V2500 Propulsion System - Nacelle **SERVICE BULLETIN**

NACELLE - EXHAUST – DRAIN MAST, THRUST REVERSER – MODIFICATION

October 5, 2000

V2500-NAC-78-0180

Thrust Reverser Drain Mast Subassembly Modification
Figure 1 (Sheet 1)

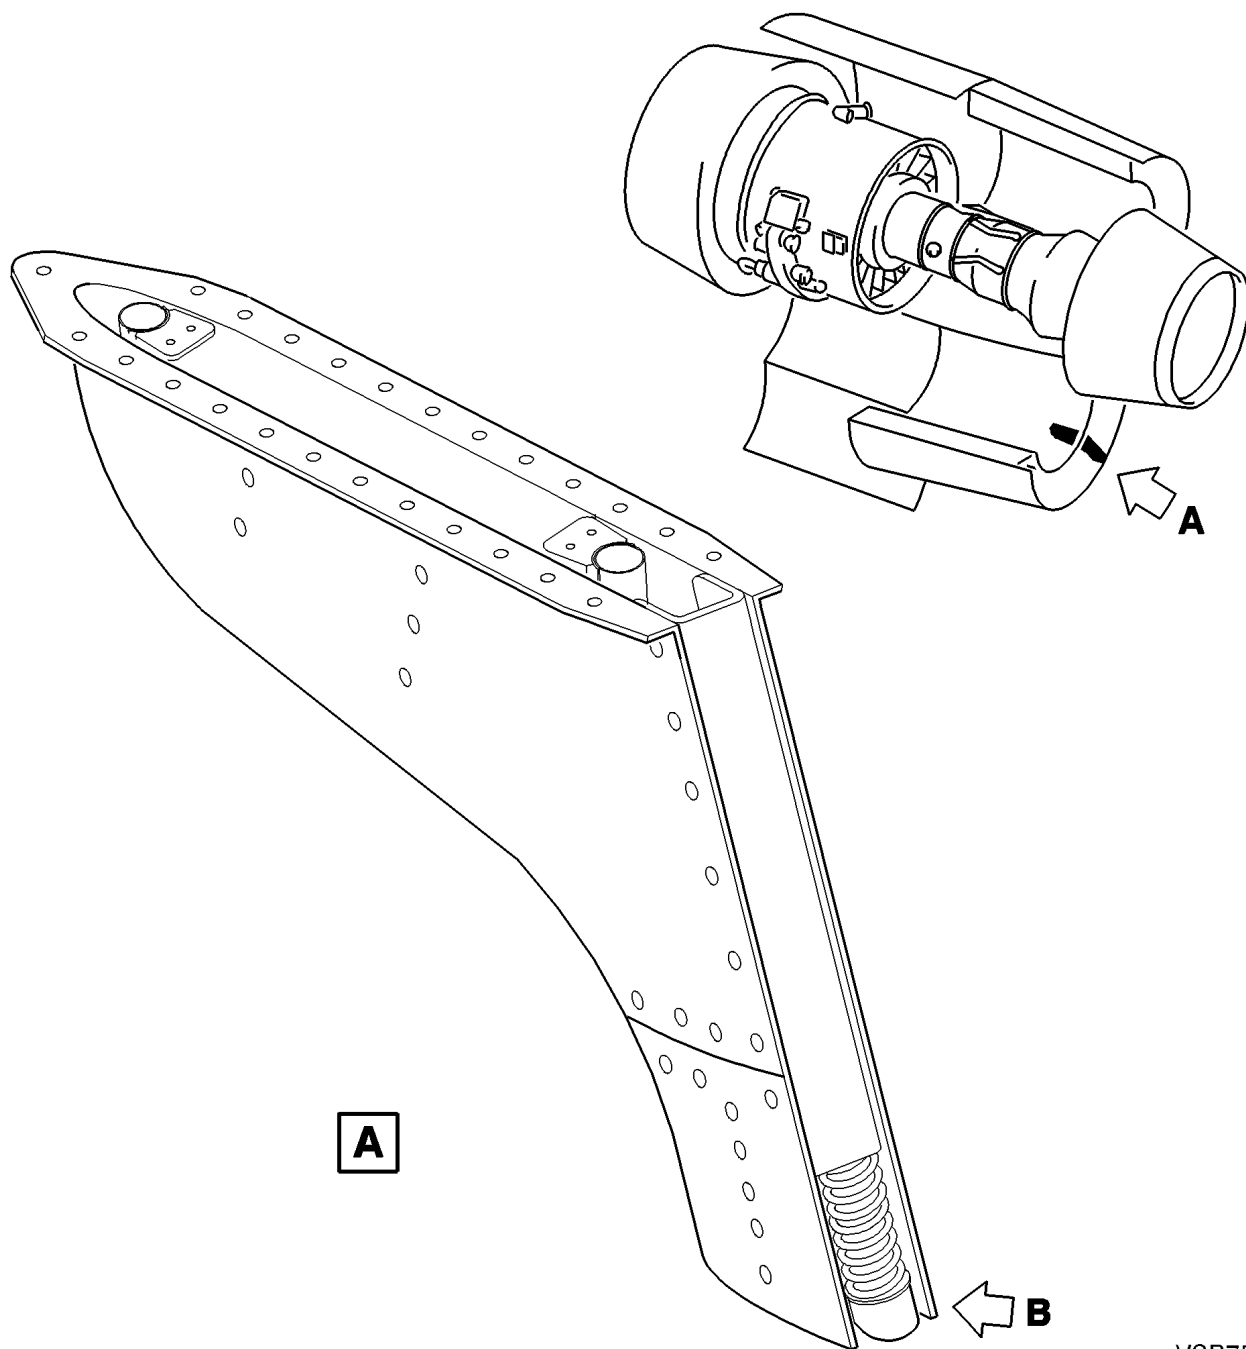
The thrust reverser drain mast subassembly is removed, disassembled, and inspected for damage. Damaged parts are replaced. If undamaged, the dry film lubricant is applied to the sleeve, the tube, and the retainers. The drain mast is reassembled with a new teflon covered spring. The drain mast subassembly is installed on the thrust reverser.

Thrust Reverser Drain Mast Subassembly Modification
Figure 1 (Sheet 2)

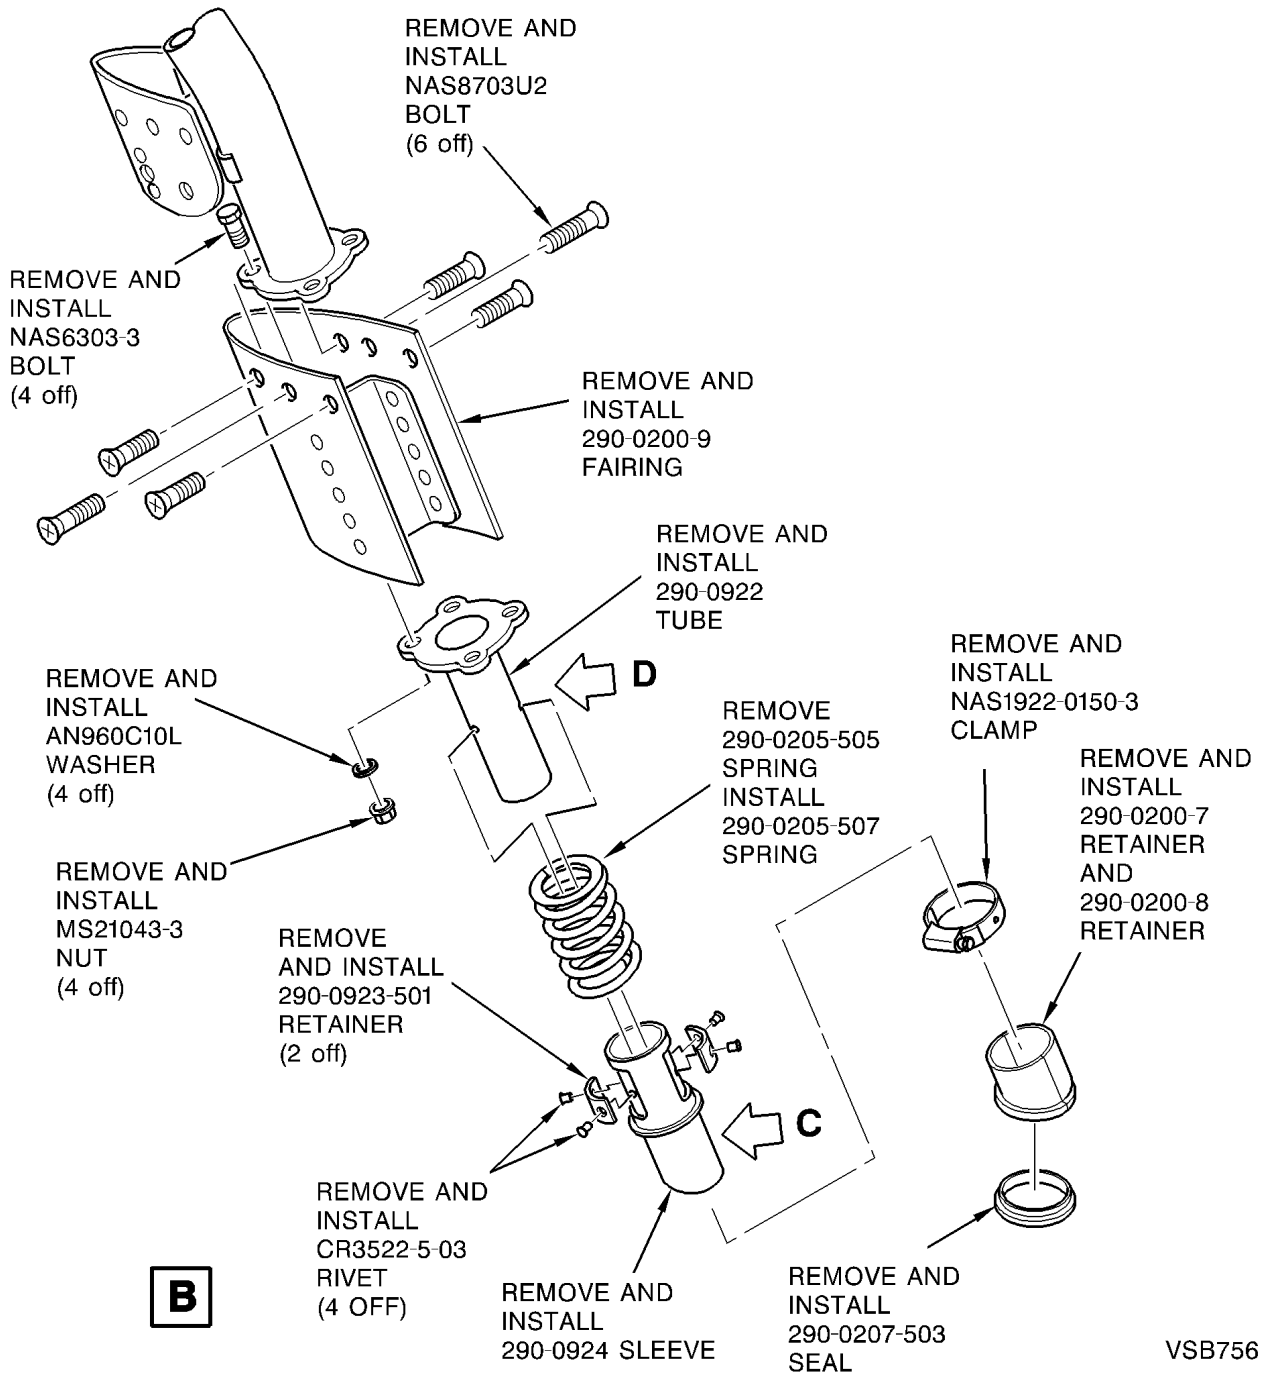
- (1) Move the translating sleeves 8 to 10 inches (20,0 to 25,4 cm) from the stowed position to get access to the thrust reverser drain mast. Refer to the MD-90 Aircraft Maintenance Manual, Chapter 78-32-00, page block 201.
- (2) Remove the nuts, washers, and drain mast subassembly. Refer to Figure 1 (sheet 2).

B. Disassemble the drain mast subassembly. Refer to Figure 1 (sheet 2).

- (1) Remove the clamp, seal retainer, and seal from the subassembly.
- (2) Remove the rivets and the retainers from the sleeve. Discard the rivets.
- (3) Remove the sleeve and the spring from the tube. Discard the spring.

- E. Assemble the drain mast subassembly. Refer to Figure 1 (sheet 2).

- (1) Install the sleeve and spring on the tube. Use the retainers and rivets.
- (2) Install the seal, seal retainer, and clamp on the tube.

- (1) Install the drain mast subassembly with the nuts and washers. Refer to Figure 1 (sheet 2).
- (2) Move the translating sleeves to the stowed position. Refer to the MD-90 Aircraft Maintenance Manual, Chapter 78-32-00, page block 201.

Thrust Reverser Drain Mast Subassembly Modification
Figure 1 (Sheet 3)

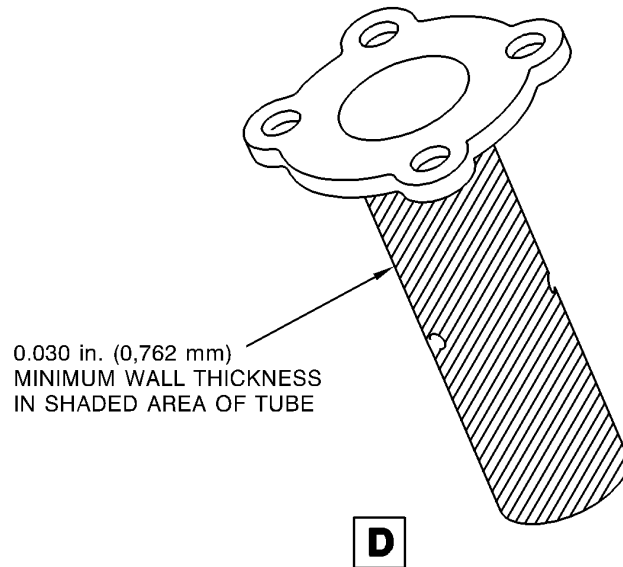
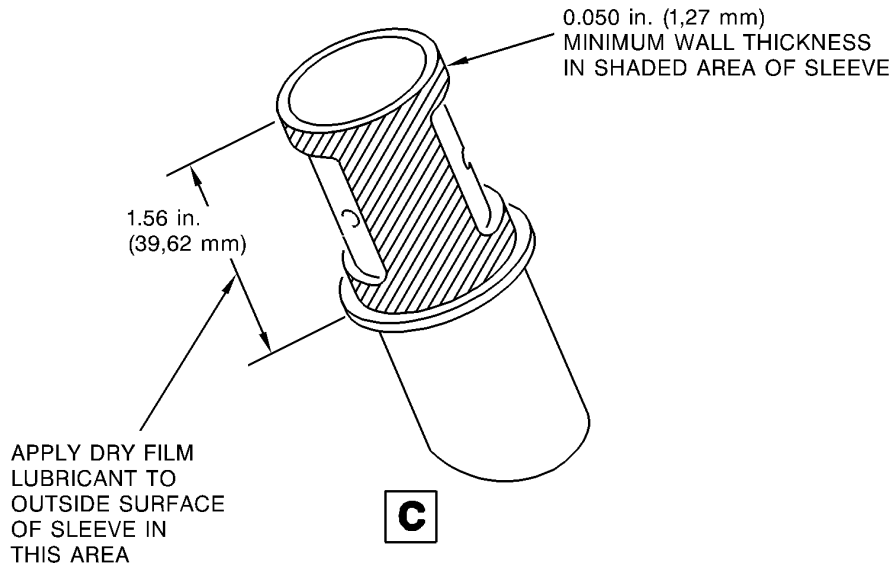
- (1) Apply dry film lubricant to the outer surface of the retainers. Apply dry film lubricant to the sleeve and tube as shown in Figure 1 (sheet 3). Refer to the Standard Practices/Processes Manual (SPP-V2500-11A), Chapter 70-38-03, TASK 78-38-03-380-501.
